Monday, May 09, 2011 7:59:23 AM

DRAWING NO. D412-664-243	TITLE CROSSTUBE ASSEMBLY (412 HI AFT)	REV. E	DART AEROSPACE LTD ENGINEERING ORDER		D.E.O. NO. D412-664-243-E-1	SHEET NO. SHEET 1 OF 2	SCALE NTS
DRAWN	CHECKED <i>MP</i>	MFG. APPR. <i>E</i>	APPROVED <i>MP</i>		DE APPR. <i>H</i>		
DATE 11.03.31	DATE 11/03.31	DATE 11.03.31	DATE 11/03.31		DATE 11.03.31

PURPOSE:

REMOVED ABRASION STRIP IN FAVOR OF A THIN LAYER OF PROSEAL 890.

D212-664-243
ASSEMBLY DETAIL

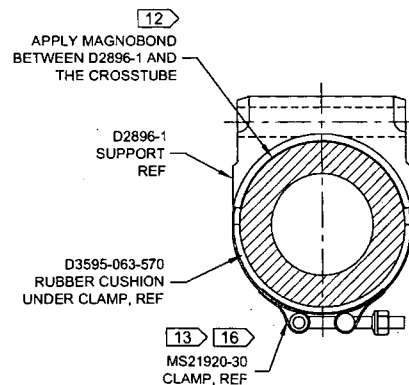
IS:

D3189-1 CHAFING SHIELD (1, INSTALLED OVER PROSEAL 890).
MS21920-28 CLAMP, 2X
2 PL

WAS:

D2856-600-1009 ABRASION STRIP
D3189-1 CHAFING SHIELD (1, INSTALLED OVER ABRASION STRIP)
MS21920-28 CLAMP, 2X
2 PL

MASK AREA PRIOR TO PAINTING AND
APPLY CLEAR COAT AFTER PAINTING
